REPLIES TO PRE BID QUERIES LOT-5 DATED - 24.04.2023						
NIT NO : PNMM/PC-183/E- 4020/NCB DATED 16.03.2023						
SUB : SUPPLY, INSTALLATION, TESTING & COMMISSIONING OF FLARE SYSTEM ON PACKAGE BASIS AT TFL						
S.NO.	SECTION NO.	PAGE NO.	CLAUSE NO.	SUBJECT	PRE BID CLARIFICATIONS	PDIL REPLY
1	Technical Specification for Supply, Installation, Testing & Commissioning of Flare System (Document No.: PC183-E-4020-SEC VI)	363 (18 of 33)	4.0 (l) - 2nd point	Structural painting with chlorinated rubber	We understand to consider painting scheme as per clause no. 5.0 of Construction, Pre-comm, Comm & start up" starting from page 94/135 (page 577 of 1266 of NIT); please review & confirm specifically paint system applicable for Flare tower/demountable flare derrick structure or advise otherwise.	Painting on Flare Stalk steel structure ans other plant structures such as Pipe racks or support structuress , shall be as per PDIL TS-2001 (ANNEXURE 7-2H) attached in NIT. Refer Clause no. 9 of TS-Civil Page 19 of 32. (As per clause- "9.0 PAINTING ON STRUCTURAL STEEL Painting on steel structures can be referred in TS2001-Painting Specification provided elsewhere in NIT. On Minor Structural Steel Sectio

PLAN VIEW- FIRE FIGHTING SYSTEM (OSBL PKG.)
SCALE 1:1150

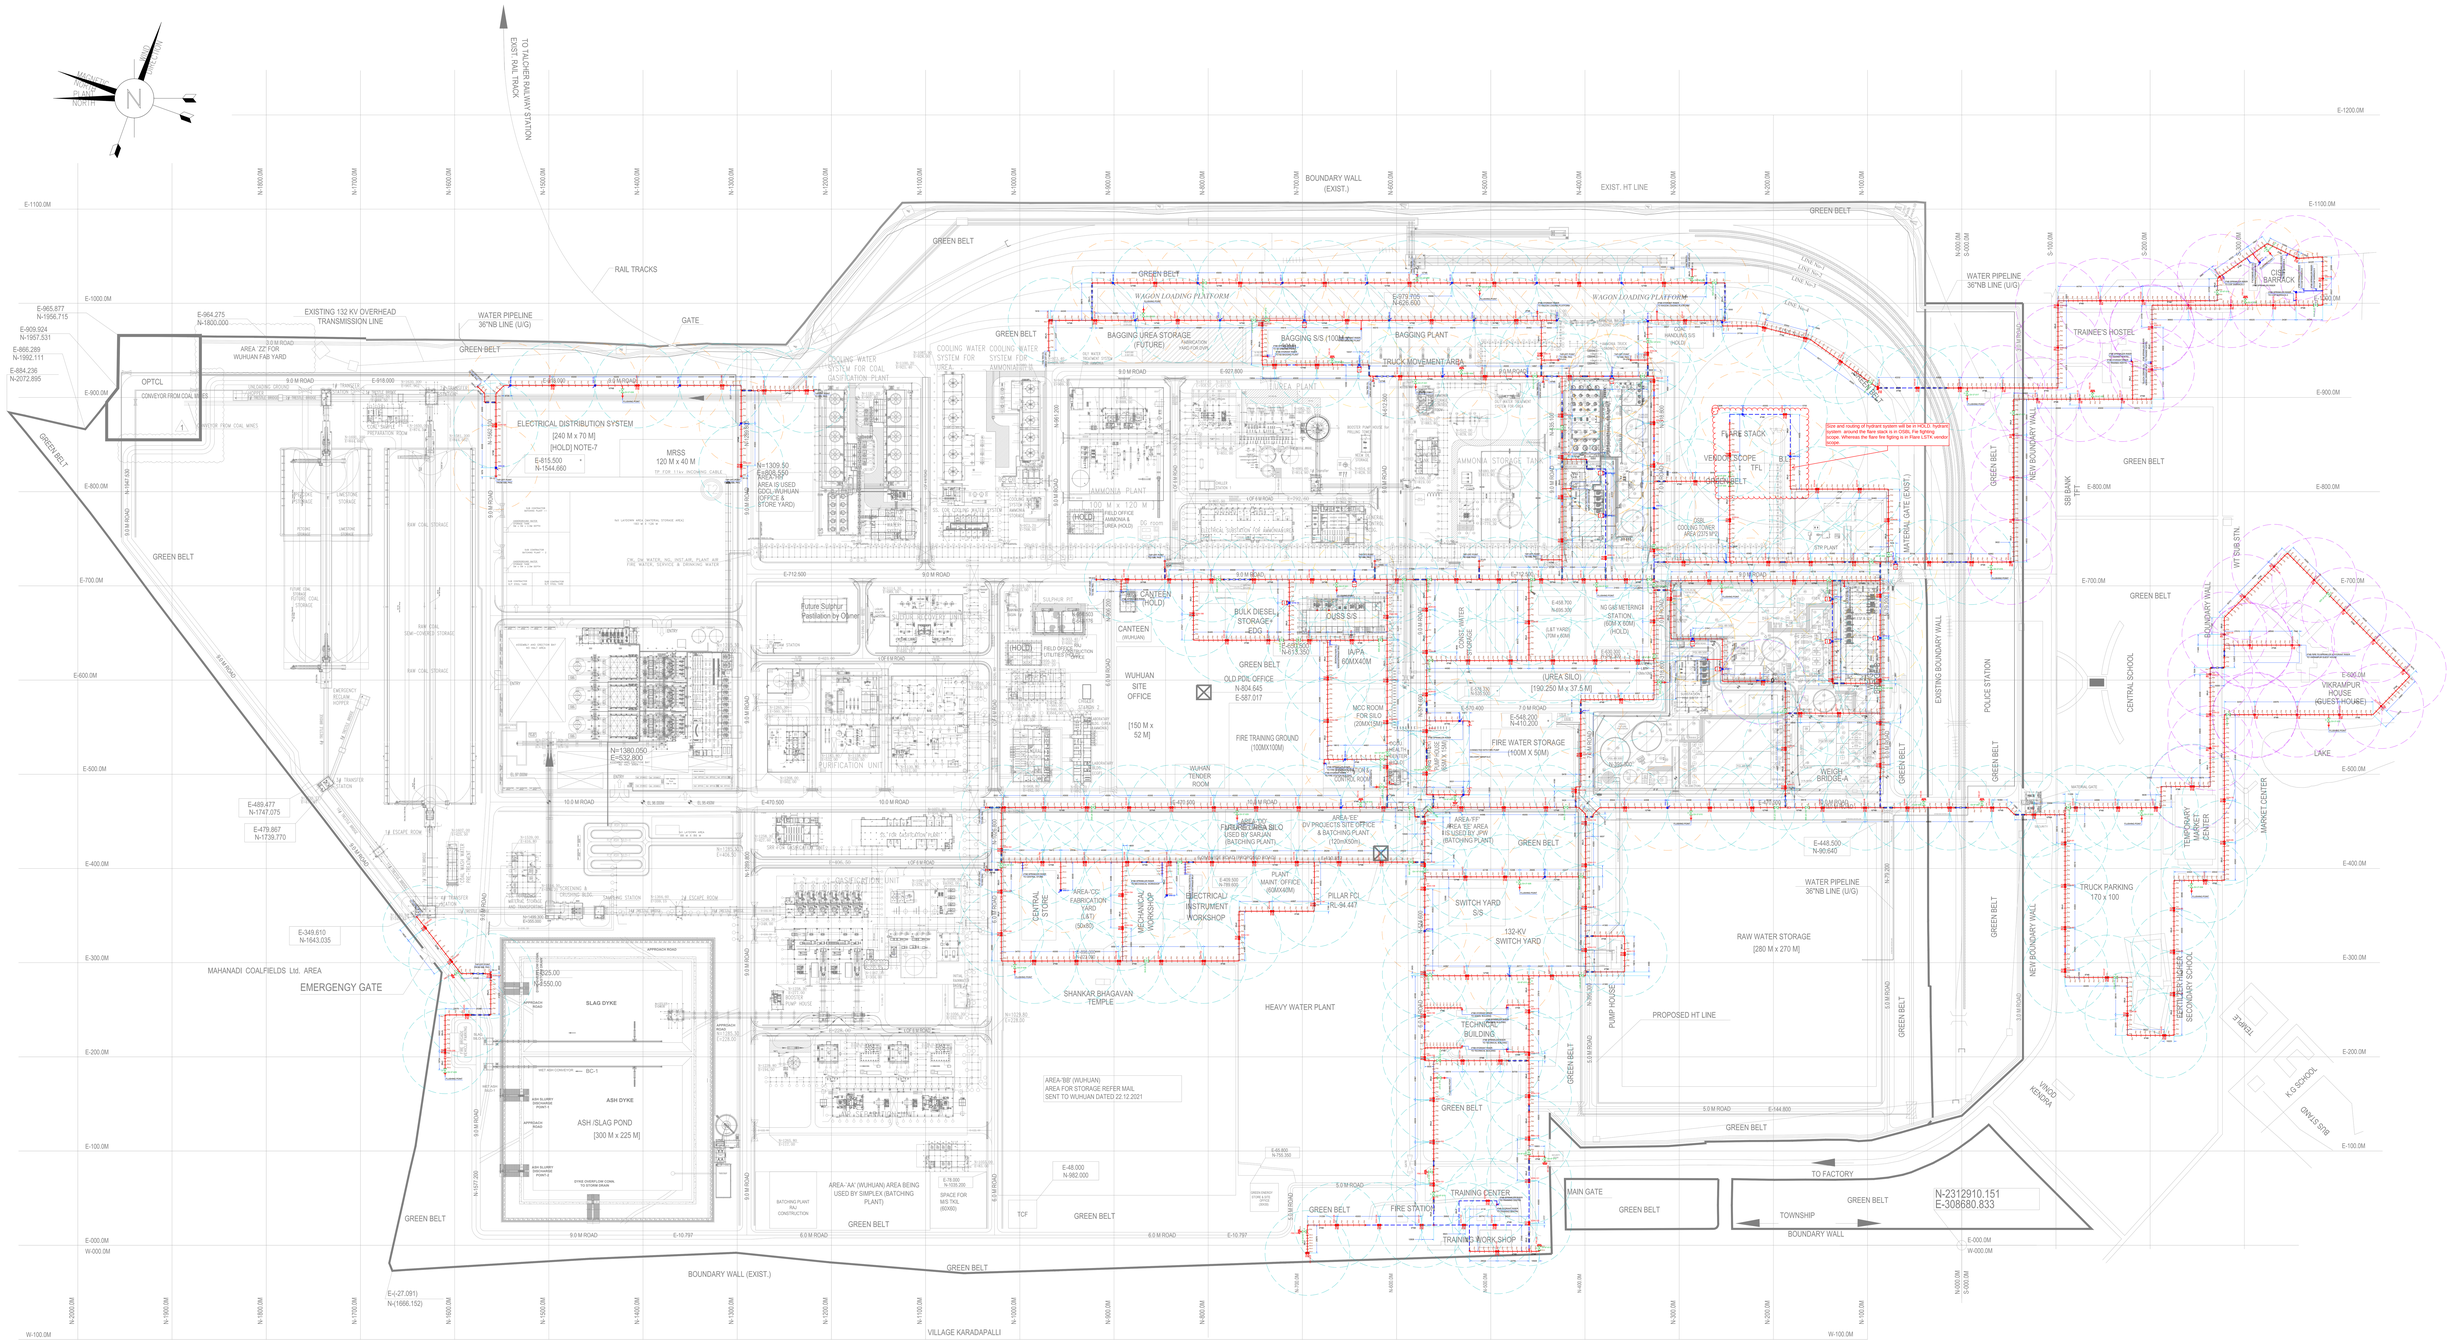
2				Plot plan & Fire fighting layout	Please provide seperate Plot plan & Fire fighting layout document. Reason being we are unable to read the document.	Please refer the attached layout- SWPL-TFL-0023-MEC-DW-002-R1_COM. LAY-HYD & SPR MAIN NETWORK FOR OSBL AREAS
3	366			Battery limit	According to document PC183-E-4020-SEC VI page number 21 of 33 which is about installation and commissioning of flares, in clauses 6.1 -III (pg 366), it is mentioned that sterile radius should be considered 90 meter. However, according to document PC183-E-4020-SEC VI page number 21 of 33 At any point within 90m sterile boundary from stack base at ground level should have maximum 1.58 Kw/m2 (excluding solar radiation0.98 kW/m2) radiations That means at the base of the stack as well as at any point within the 90 m boundary the limit is 1.58 Kw/m2. Kindly confirm if our understanding is correct or not.	The maximum Radiation intensity is 1.58 Kw/m2 (excluding solar radiation 0.98 kW/m2) at any point within 90m sterile boundary from stack base at ground level.

Size and routing of hydrant system will be in HOLD. hydrant system around the flare stack is in OSBL Fire fighting system. Whereas the flare fire fighting is in Flare LSTK vendor scope.
